City of Hapeville

Design Review Committee

January 16, 2019

RE: Design Review - 903 Margaret Street

PROJECT NO.: L16158
SITE PLAN
903 MARGAERT
DRAWN BY: LGS/TLM
SCALE: 1" = 20'
DATE: 05-08-2017

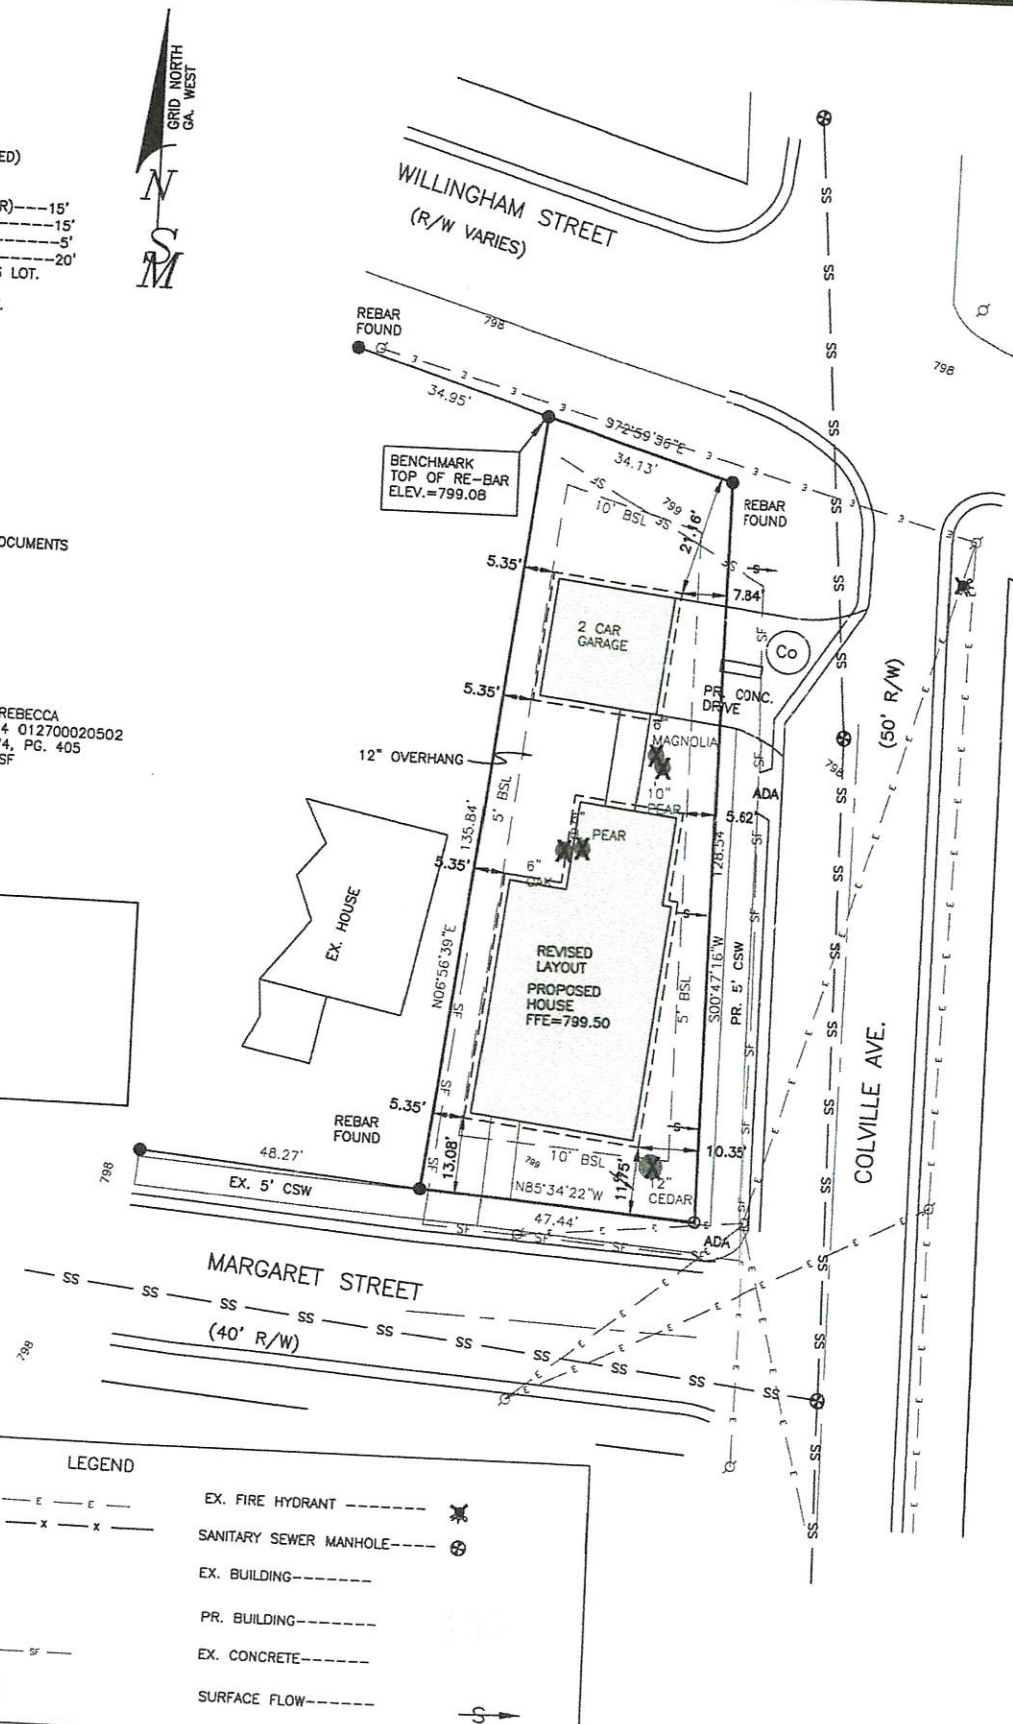
STAFF COMMENT: Driveway is 20' wide to accommodate corner lot. Design exception is required.

Driveway is 20' wide to accommodate corner lot. Design exception is required.

EXTERIOR ELEVATION

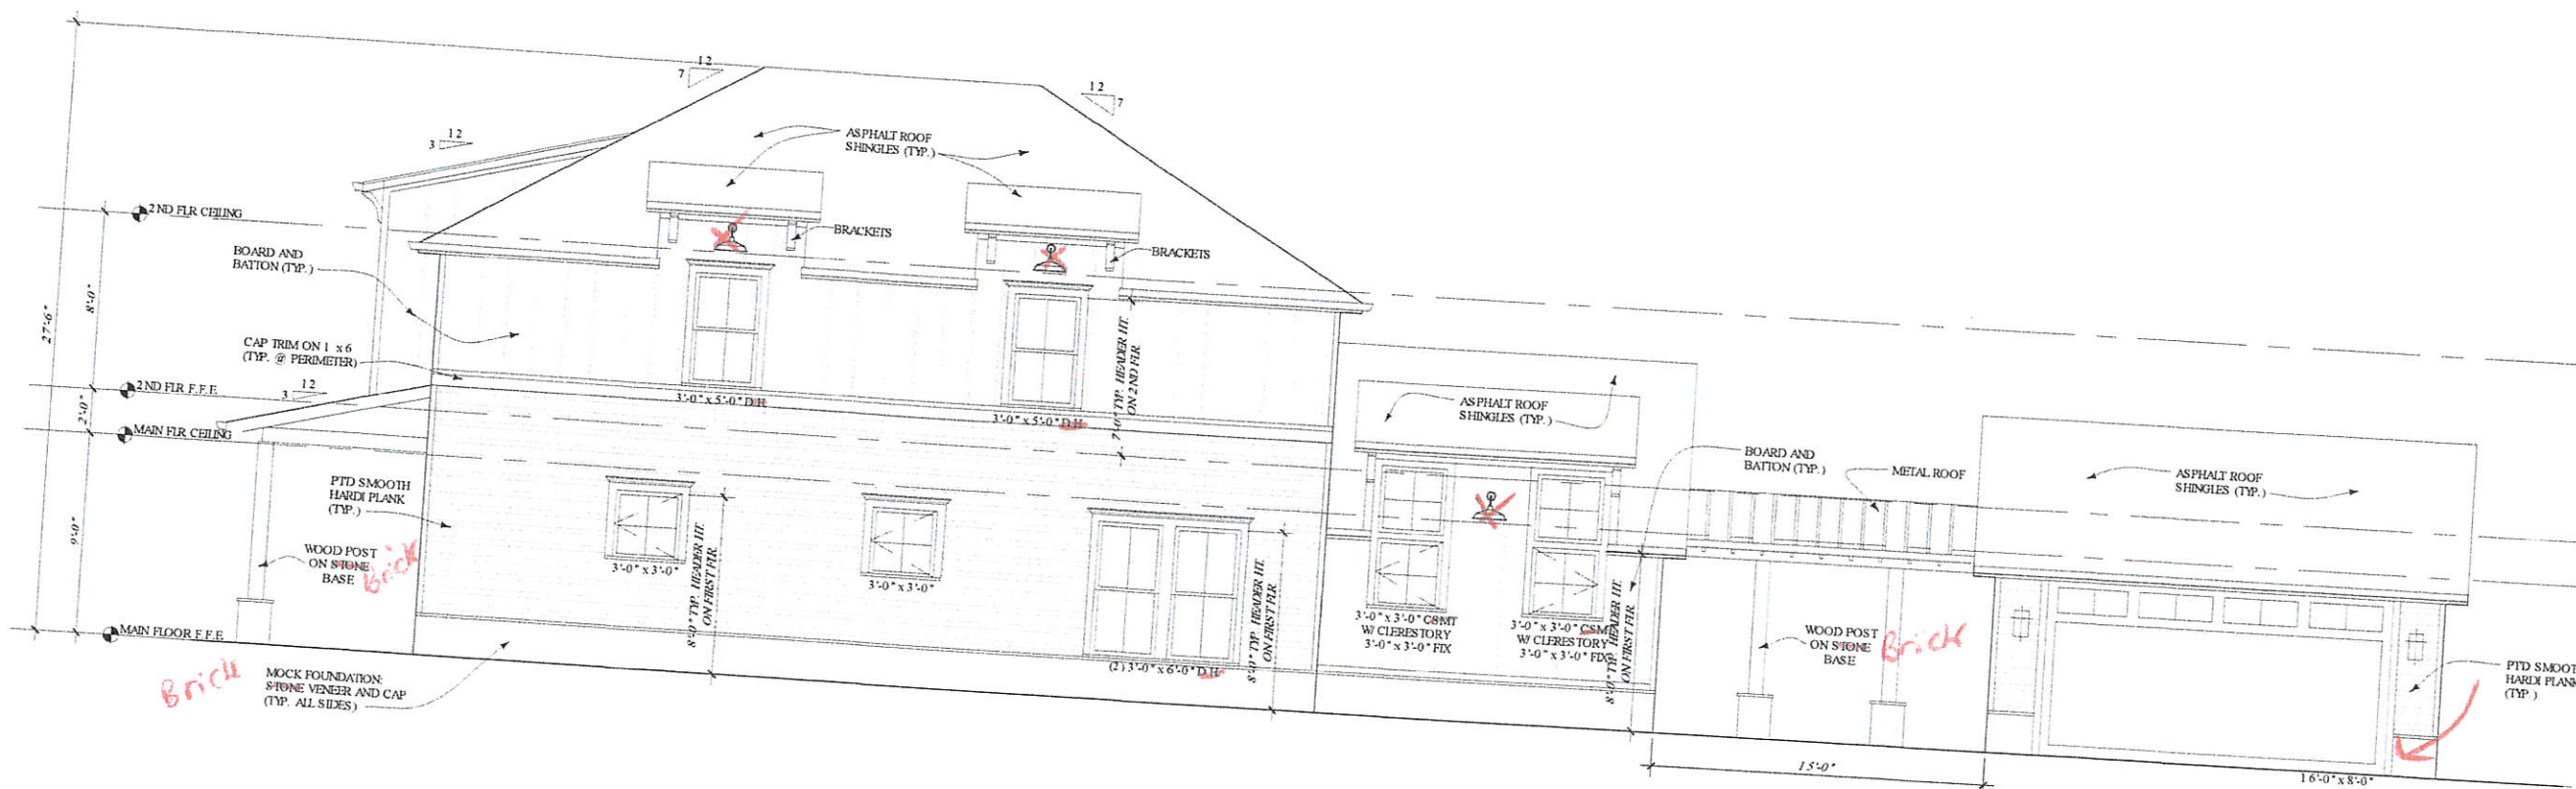
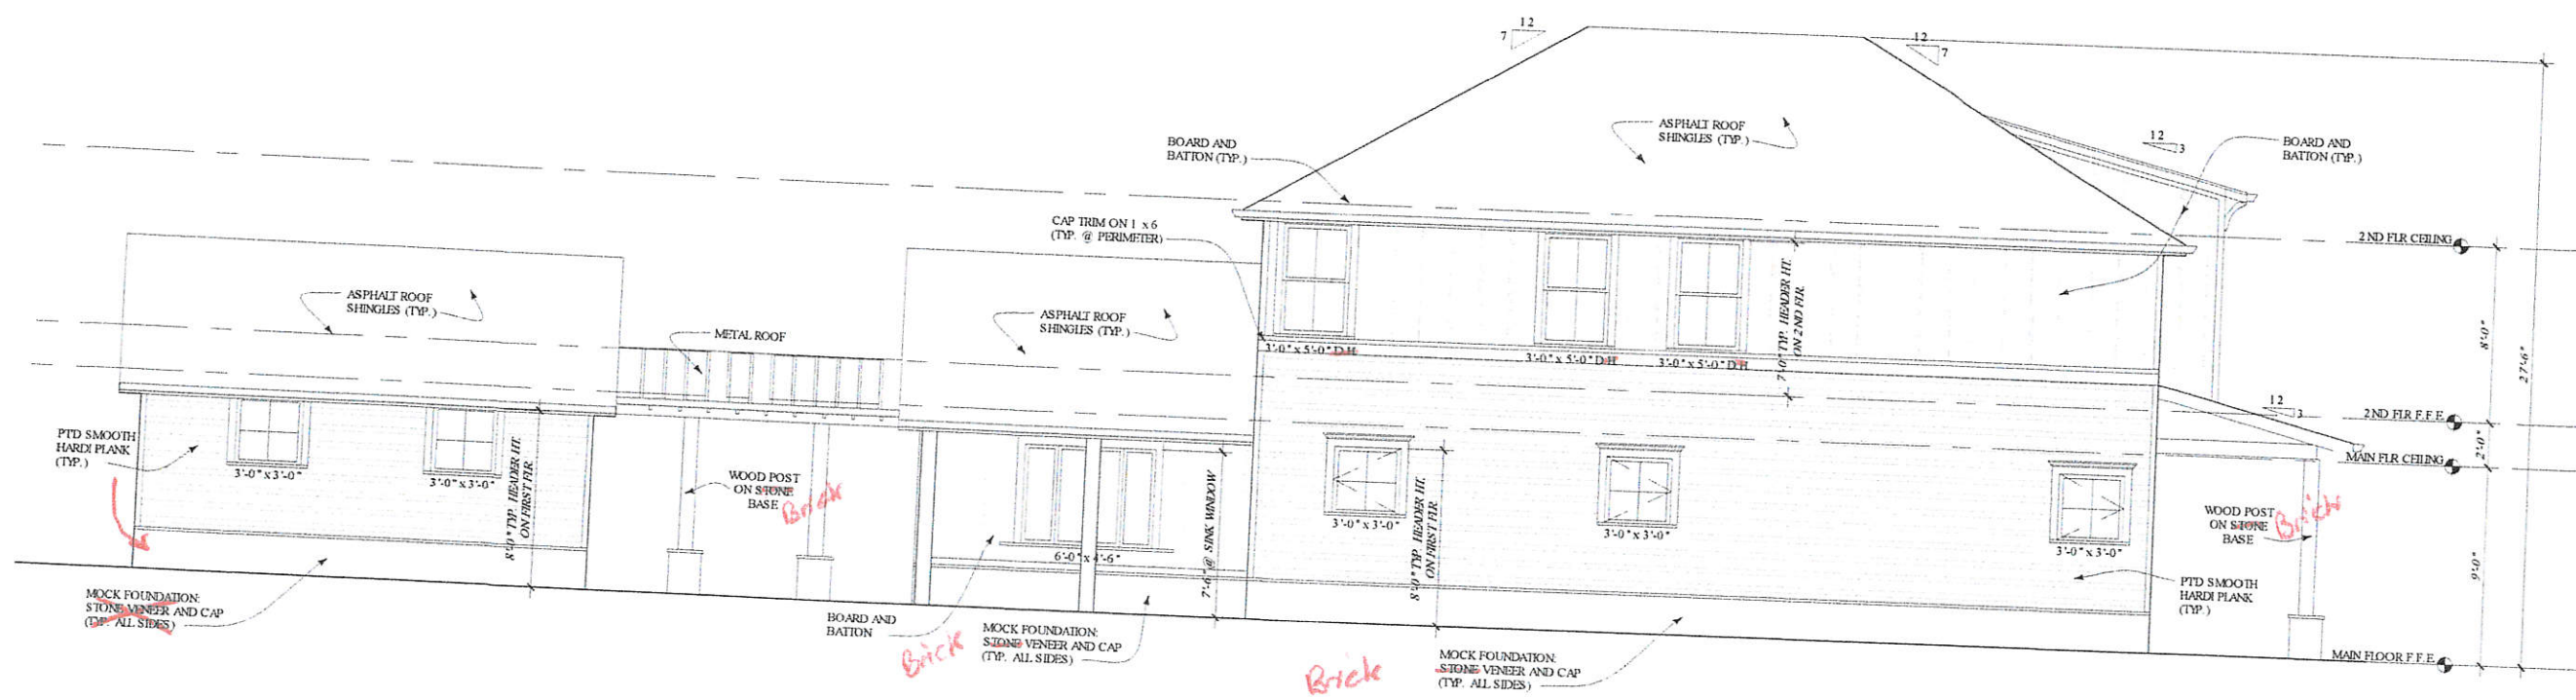
STAFF COMMENT: **House is built on slab at grade.**
 Sill dimension from finished floor elevation should be provided.

House is built on slab at grade. Design exception is required.

Sill dimension from finished floor elevation should be provided.

Sill material should be specified.

Building numbers should be provided.

Porch finishes should be provided.

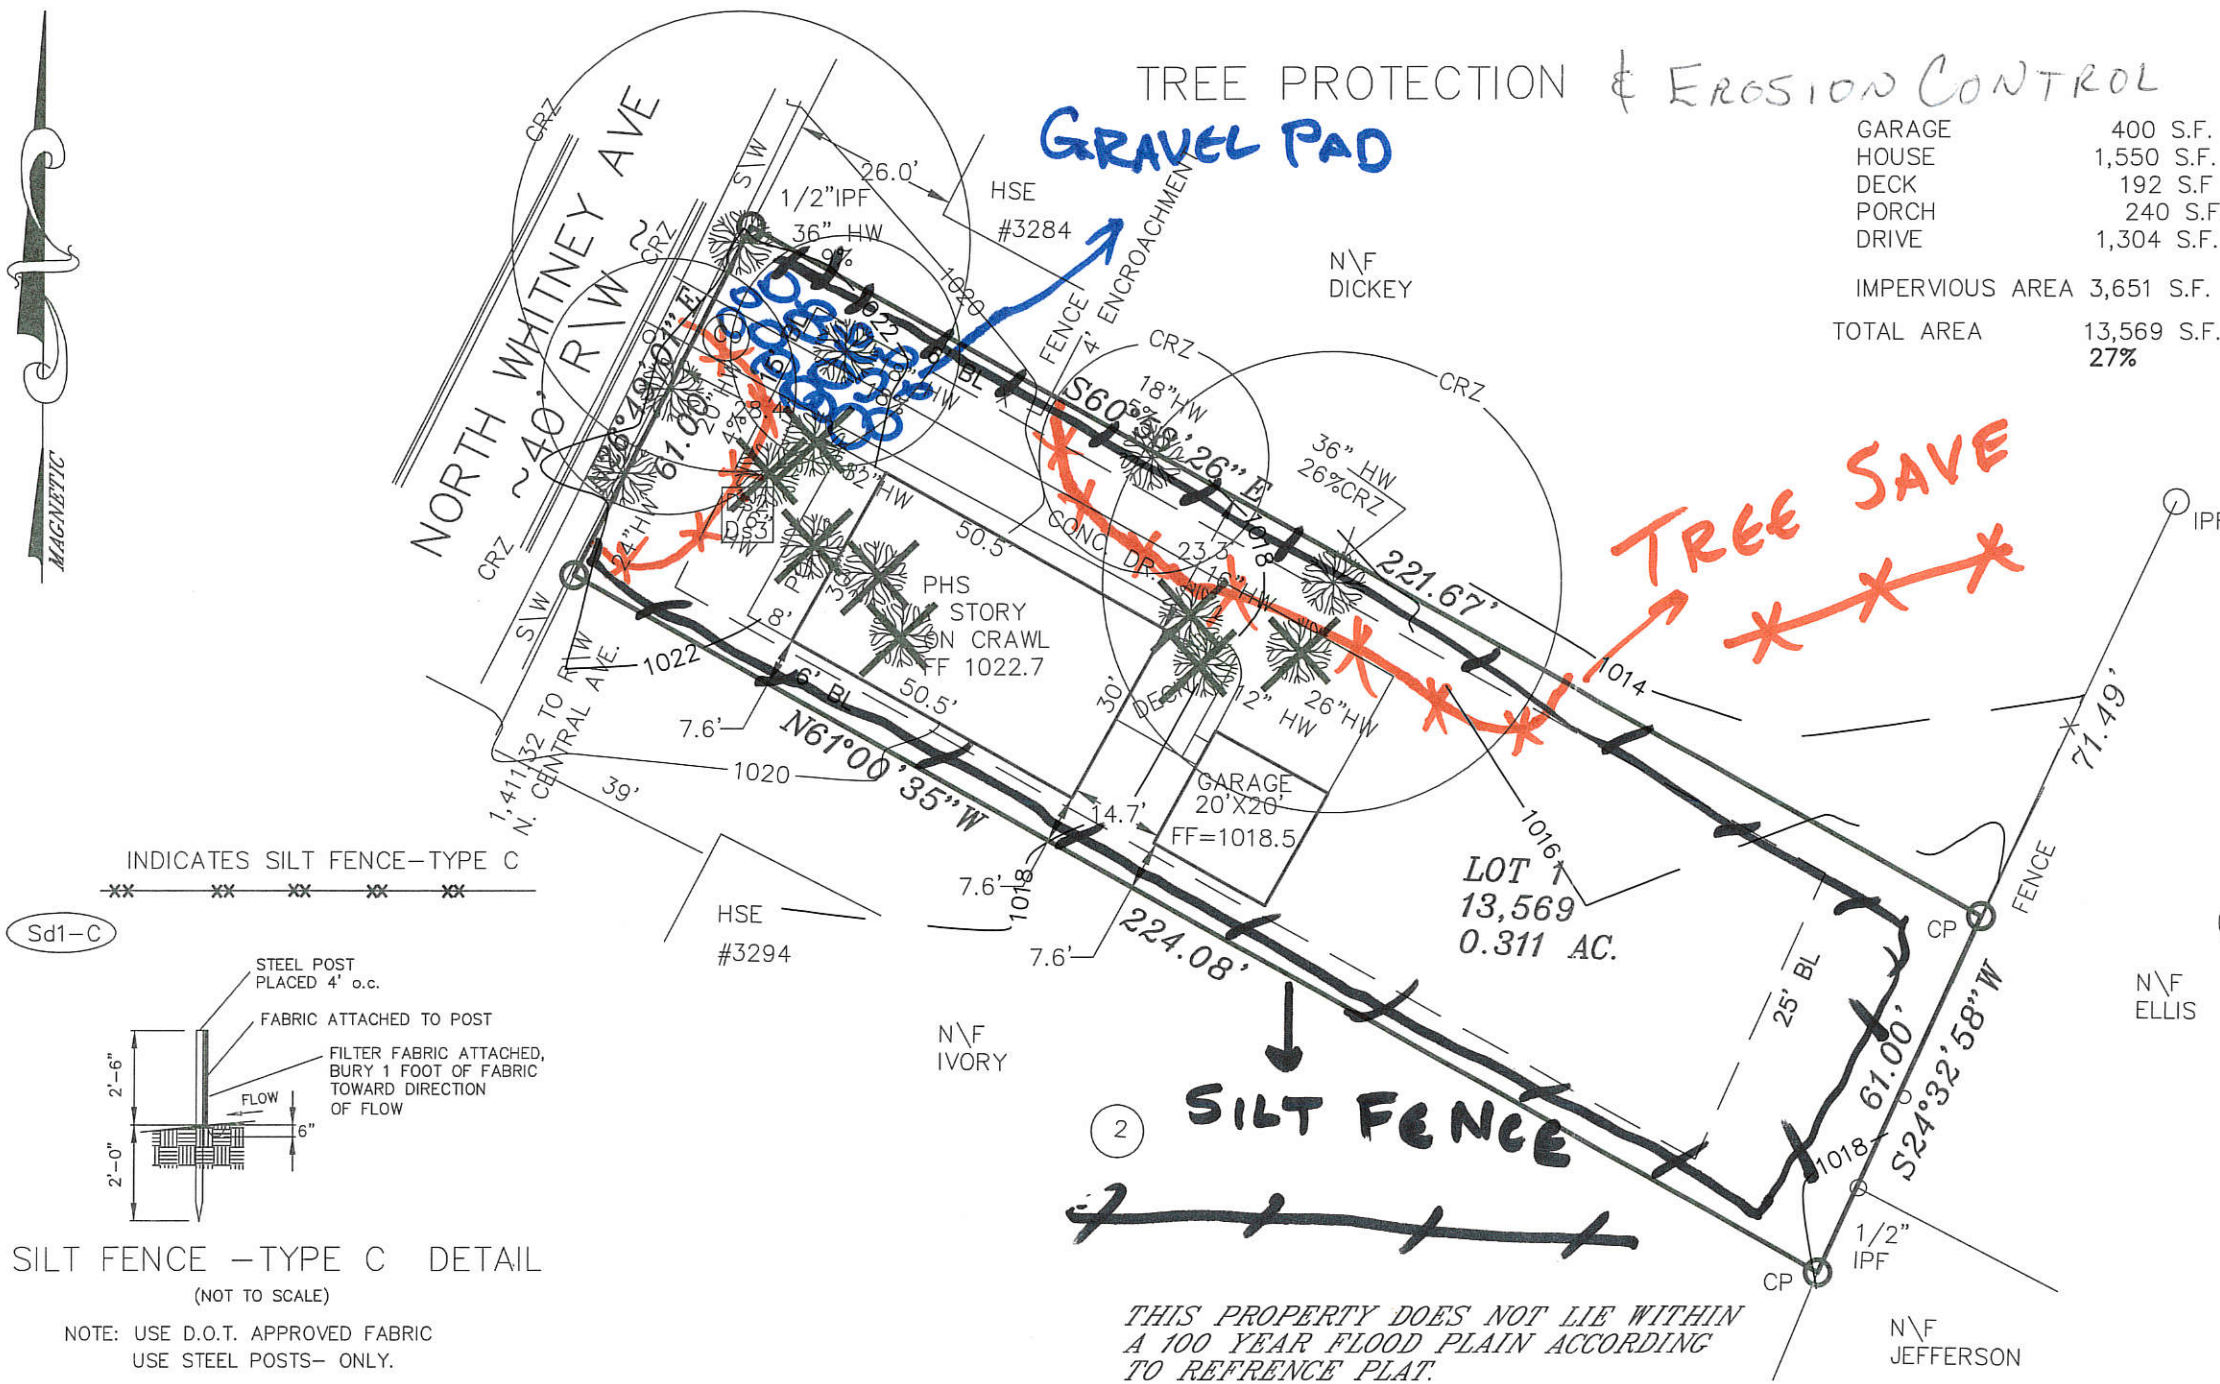
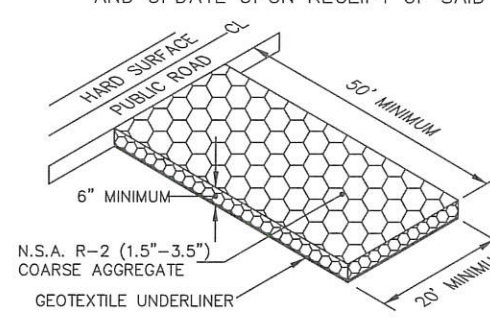
Walkway should be included in the plan.

Applicant should provide plans for outbuilding.

Applicate should verify if outbuilding is at least ten feet from the adjoining lot.

The site plan is being reviewed through the Planning Commission on 1/16. The planner's report indicated all setbacks and height requirements have been met.
